PROJECT MAUI - ONCOLOGY

WARRINGAH ROAD & WAKEHURST PARKWAY, FRENCHS FOREST

SCHEDULE OF CHANGES	DEVELOPMENT APPLICATION Rev Revision Description Date
00. Change in layout and heights of	A Section 4.55 Update 23.06.202 B For Section 4.55 application 30.06.202
plant and mechanical overruns. External louvre screening updated to suit.

Maui - Healthcare Warringah Road & Wakehurst Parkway, Frenchs Forest, NSW Section 4.55 Modification

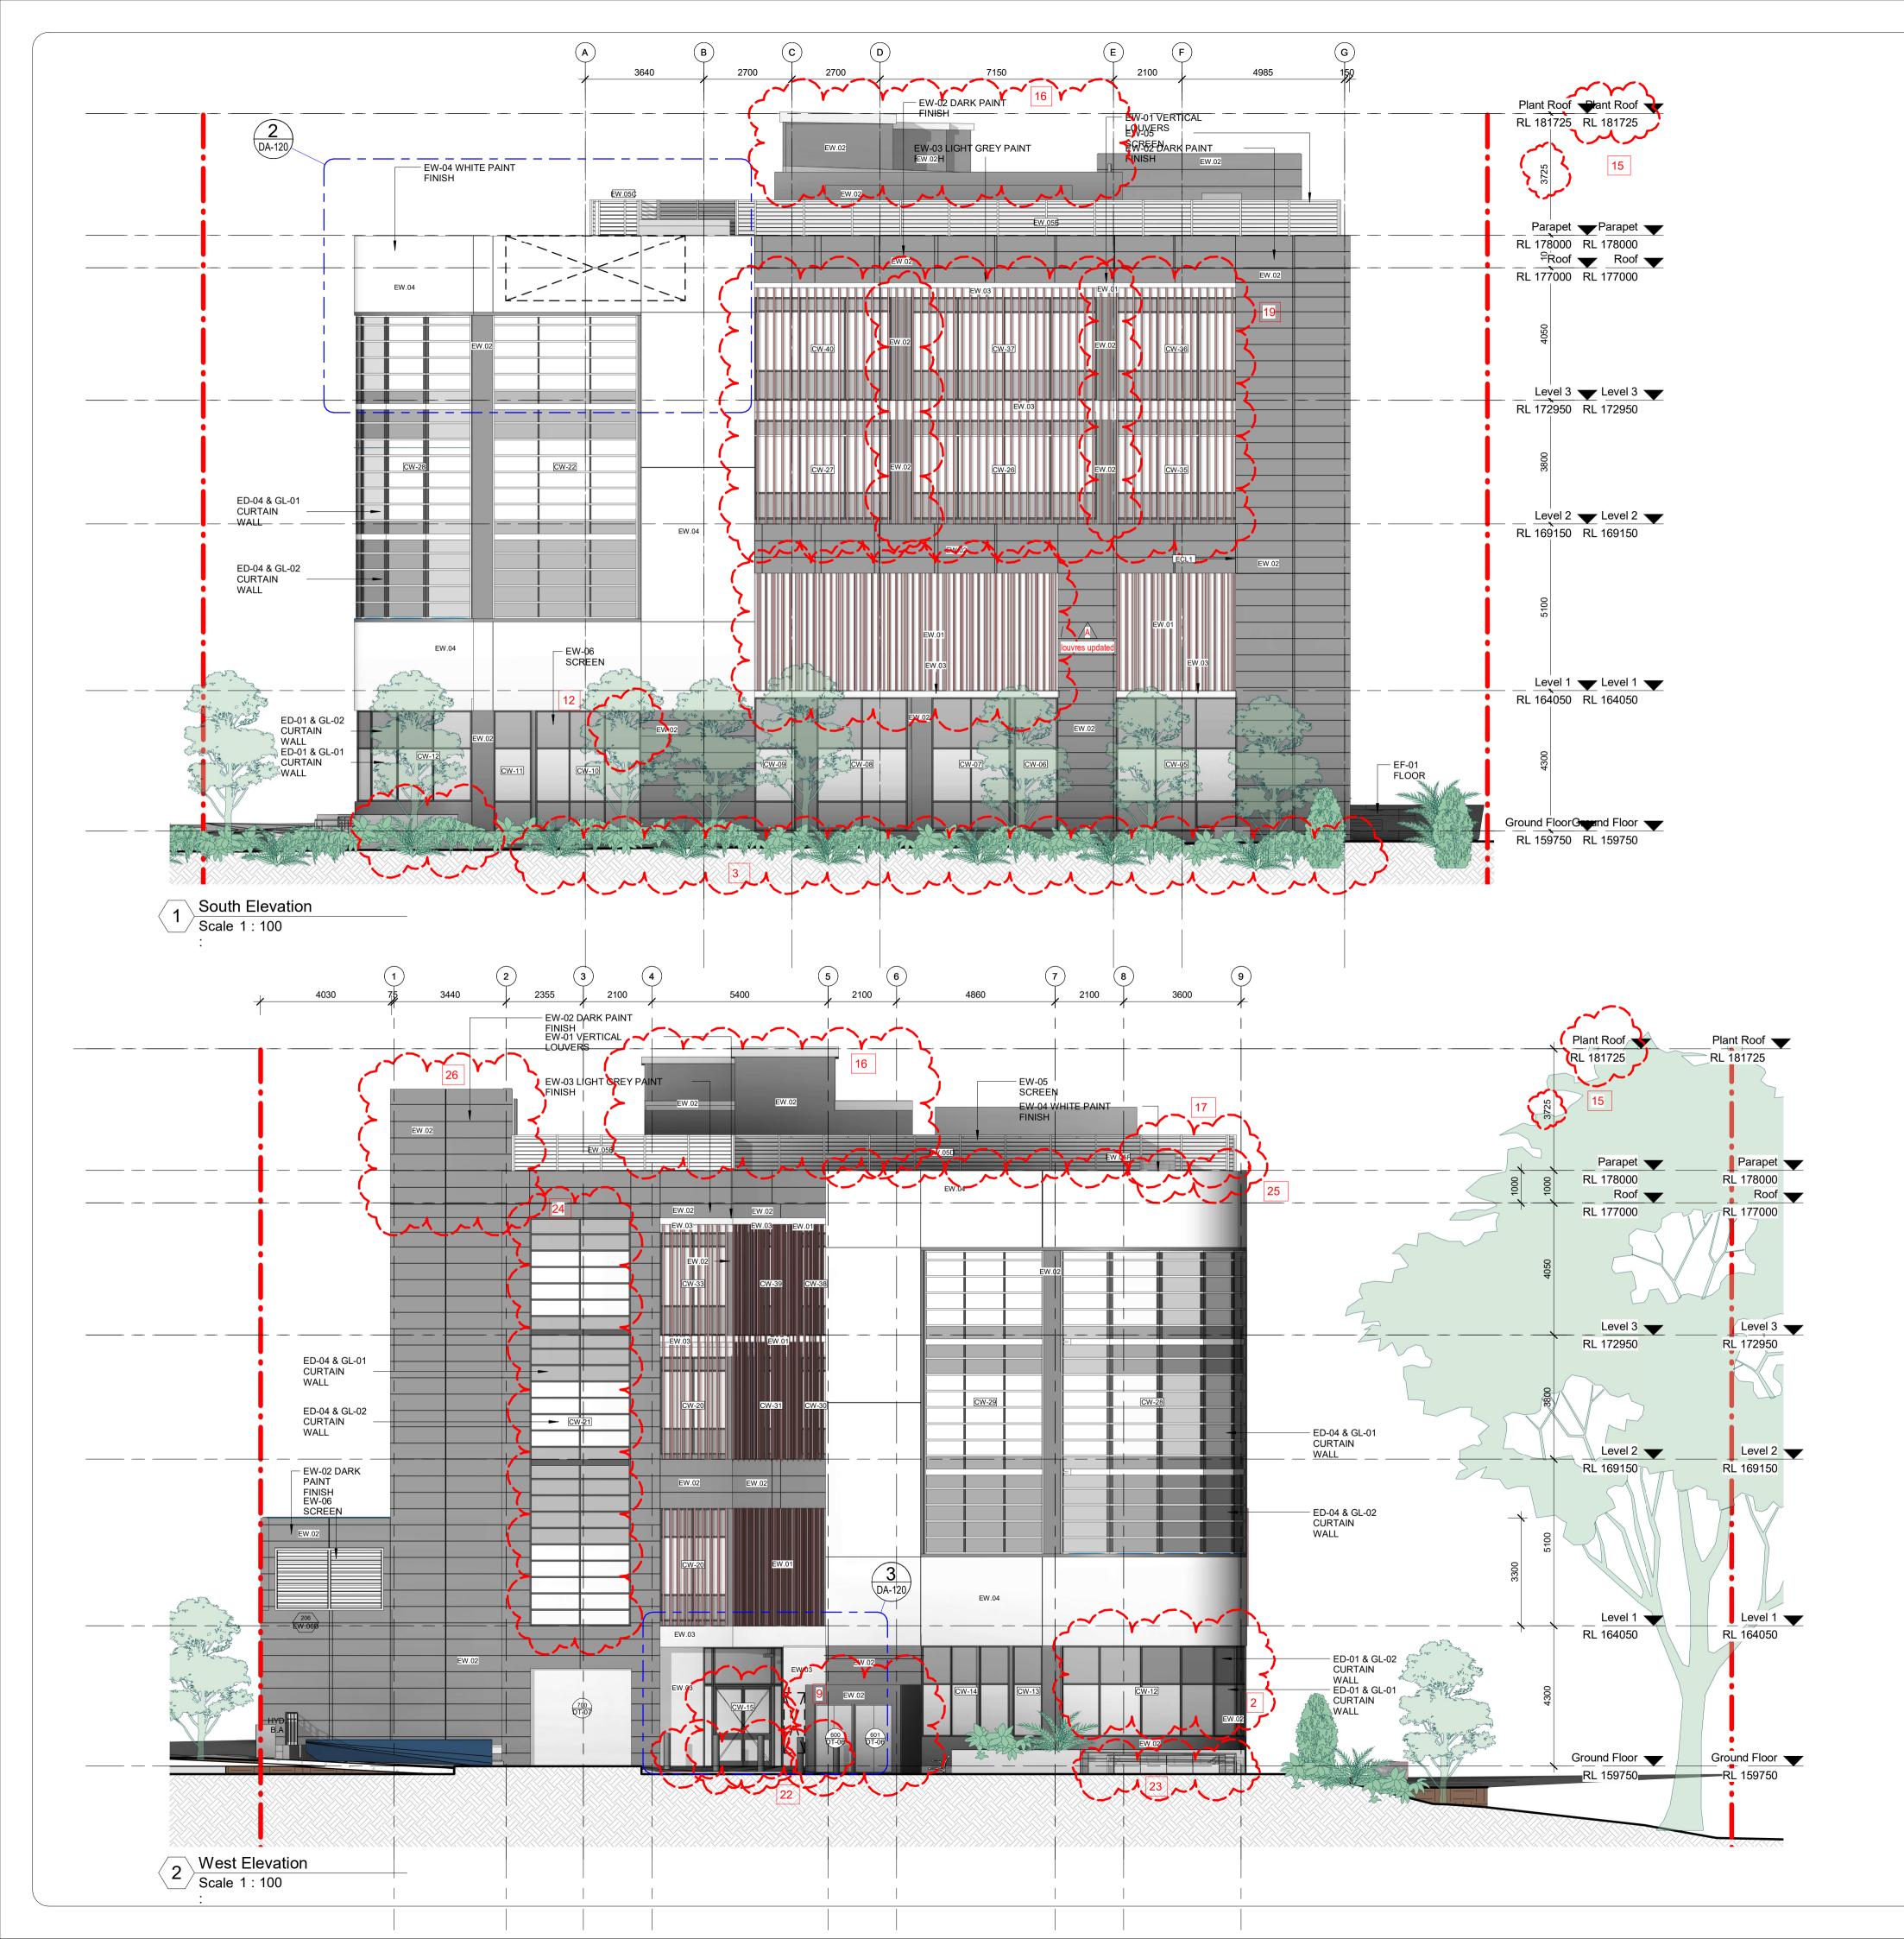
DF	DRAWING STATUS:	
SCHEDULE OF CHANGES	Rev A	Revision Description Section 4.55 Update	Date 23.06.2022
00. Change in layout and heights of	В	For Section 4.55 application	30.06.2022
plant and mechanical overruns. External louvre screening updated to suit.			
 Hydrant booster reocated Stair and glazing shifted inwards

3. Landscaping updated			
4. Row of panels added5. Louvre size updated			
6. Window shifted to accomodate	©Copyright 1	Team 2 Architects	
columns 7. Levels updated	This drawing Copyright Ac reproduced,	g is protected by copyright. All right are reserved. Unles ct 1968. No part of this drawing may in any form or by a published, broadcast or transmitted without the prior w	ny means be vritten permission of

8.Service penetrations added 9. Sprinkler control valve, booster	Construction Team 2 Arch injury wheth	It owner. Please Note: If the status of this drawing is not in it may be subject to change, alteration or amendment litets. If so, Team 2 Architects is not liable for any los er special, consequential, direct or indirect, suffered by	at the discretion of s, damage, harm or / you or any other
assembly and hydrant booster assembly	person as a	result of your use of this drawing for construction purp DRAWING	US 85.
moved. 10. Height lowered by 360mm	specification proceeding v		ects before

11. Changed from curved glazing to polygonal	2. All dimensible obtained I 3. All dimension	sions and levels are in millimeters unless noted otherwise by scaling the drawing. sions to be checked on site with any discrepancies refer efore proceeding with work.

12. Louvre removed	4. All work to	o be carried out in accordance with the requirements of t rrent NCC & Australian standards.	he principal certifying
13. Balustrade deleted14. Width reduced		EASEMENTS INDICATIVE, TBC AS CUP	RRENTLY

15. Increased by 25mm 16. Change to layout and height of			
overuns. 17. Louvres extended			
18. Window size reduced			
19. Glazing and Louvre layout and sizes updated			
20 Louvres deleted, glazing reduced 21. Reduced from 150 before

22. Bollards removed			
23. Planter bed height, balustrade length increased			
24. Window height reduced by 200mm 25. Height reduced			
26. Height increased by 200

South Elevation - Warringah Road Streetscape Scale 1 : 200 1

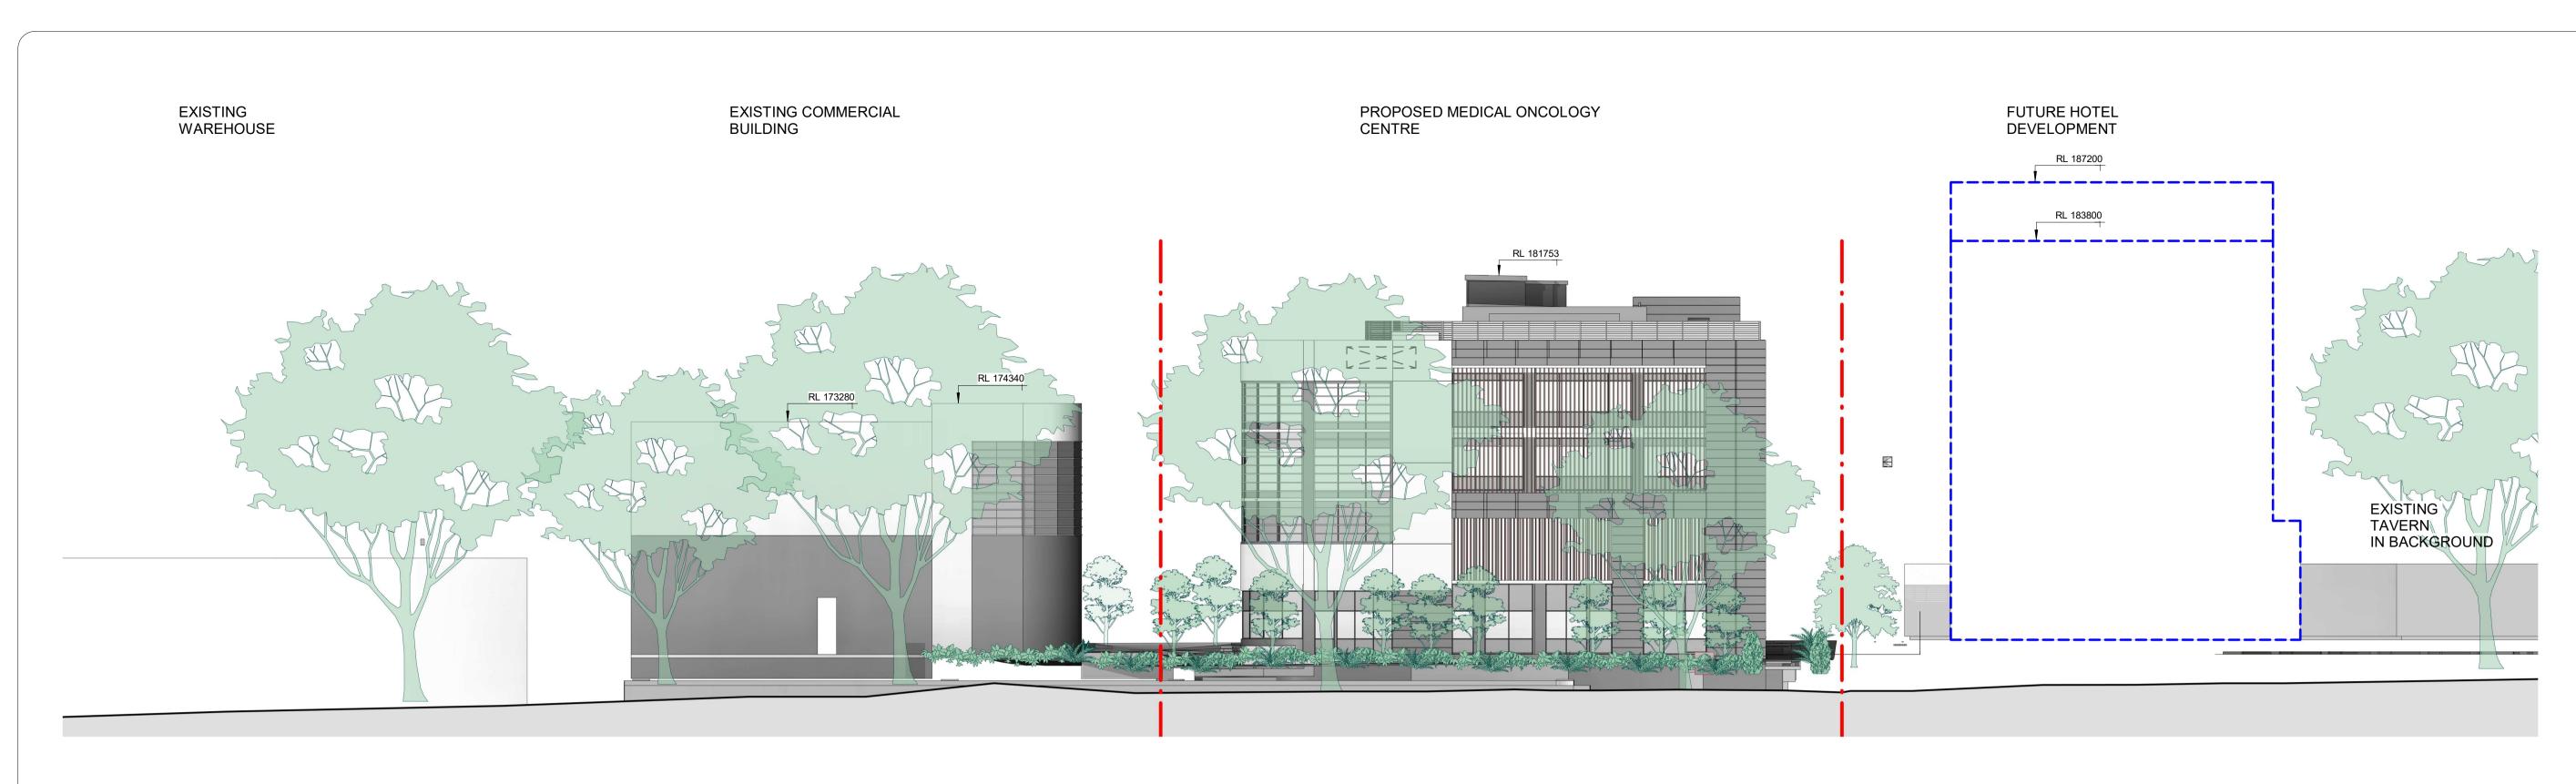
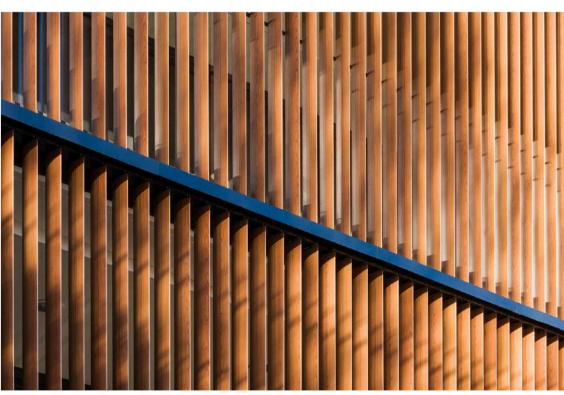
. Change in layout and heights of
	nt and mechanical overruns. External vre screening updated to suit.
	Hydrant booster reocated
	Stair and glazing shifted inwards
	Landscaping updated
	Row of panels added
	Louvre size updated
	Window shifted to accomodate umns
	Levels updated
	Service penetrations added
	Sprinkler control valve, booster
as	sembly and hydrant booster assembly
	oved.
	. Height lowered by 360mm
	. Changed from curved glazing to
	lygonal . Louvre removed
	Balustrade deleted
	. Width reduced
15	. Increased by 25mm
	. Change to layout and height of
	eruns.
	. Louvres extended . Window size reduced

-	. Glazing and Louvre layout and sizes
	dated
	Louvres deleted, glazing reduced
	. Reduced from 150 before
	. Bollards removed
	. Planter bed height, balustrade length
	reased Window beight reduced by 200mm
	. Window height reduced by 200mm . Height reduced
	. Height increased by 200
	. Finishes updated
	•

Client	Genesis Care 11/ 41-43 Bourke Rd, Alexandria, NSW, 2015 (02) 8236 3300
Architect	Team 2 701/1 Chandos Street, St Leonards, NSW, 2065 (02) 9437 3166
Drawing No.	Drawing Name Plant Schedule

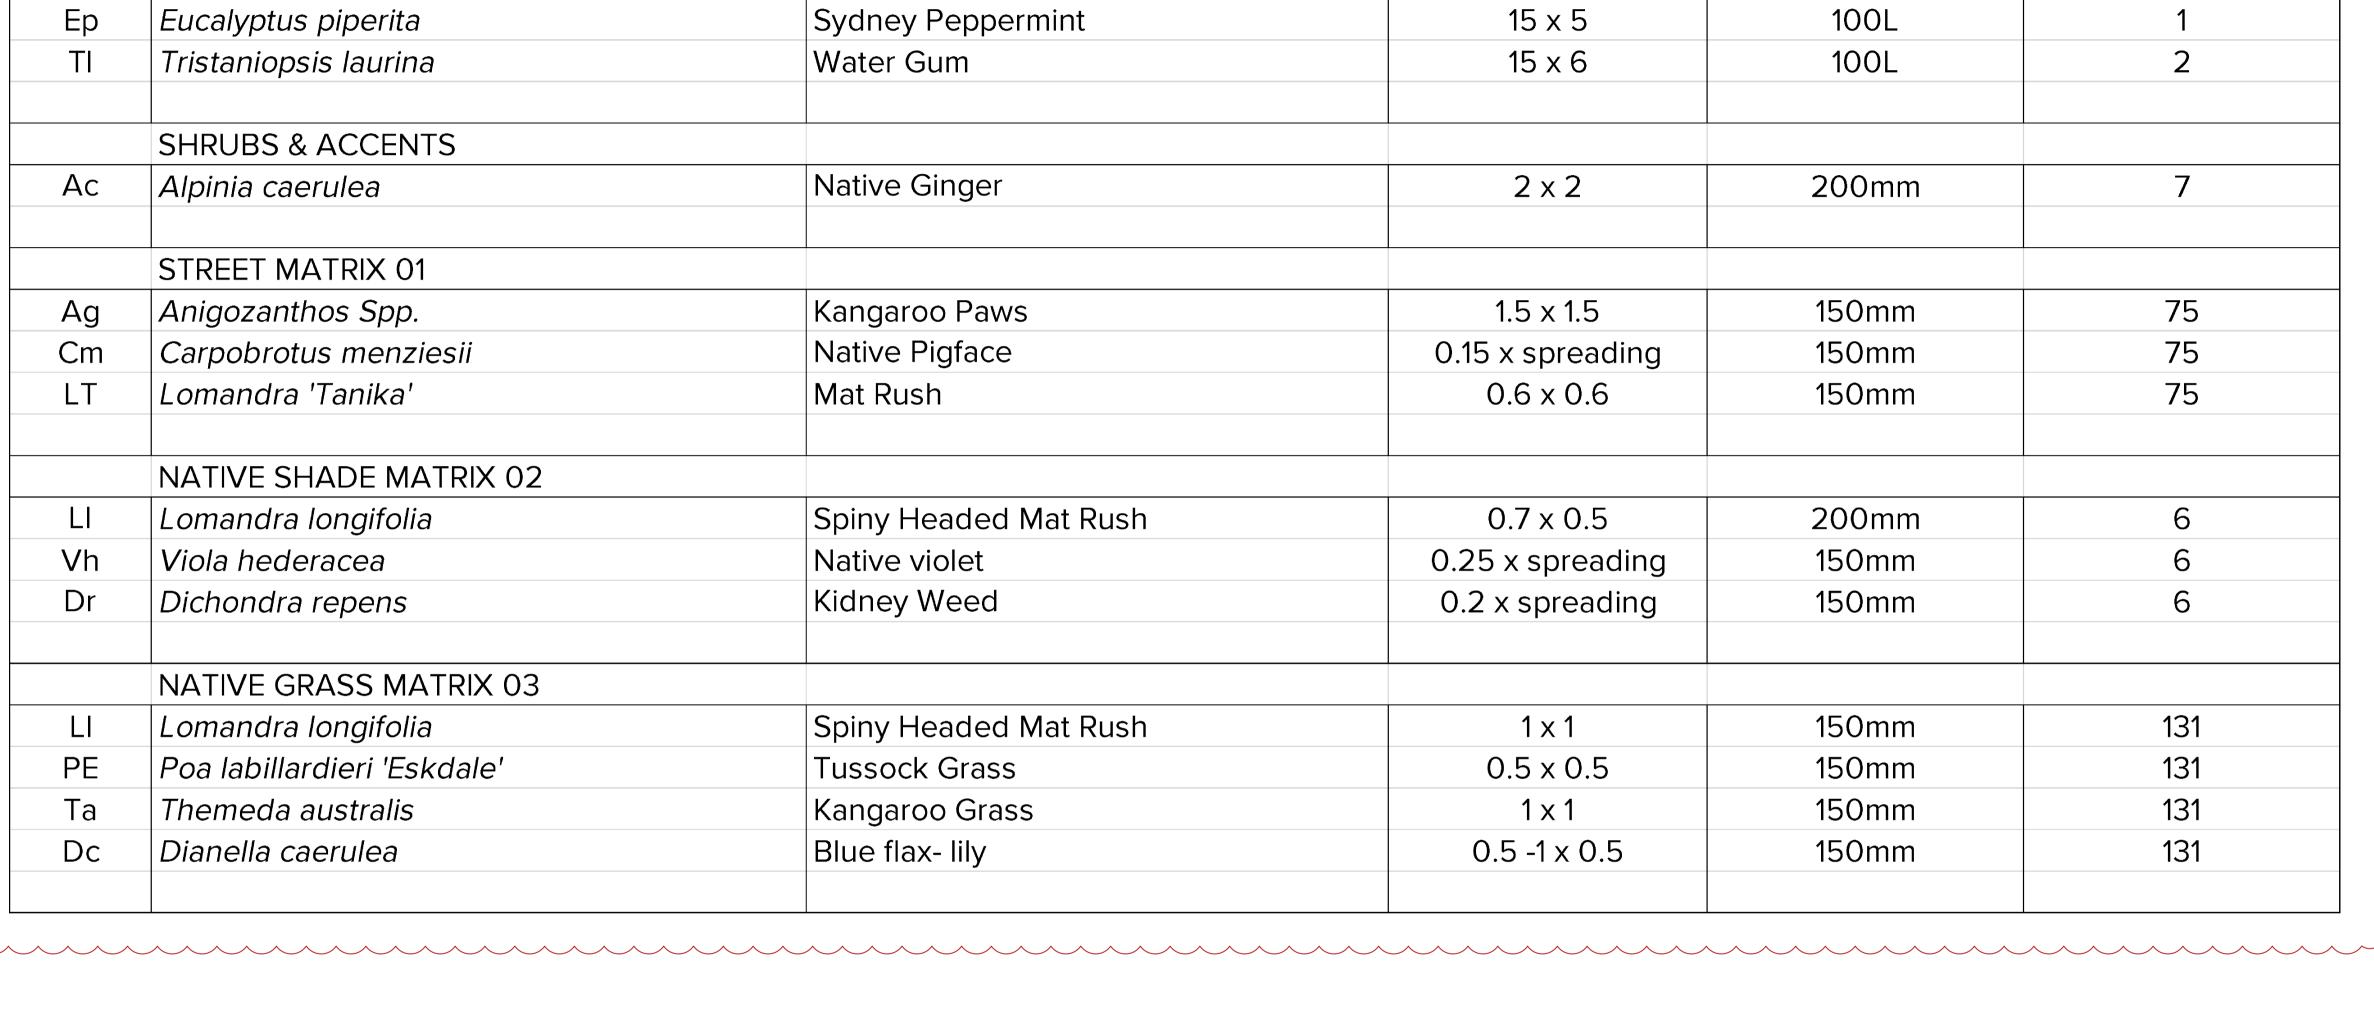
SCHEDULE OF CHANGES: 18. Plant Schedule updated.
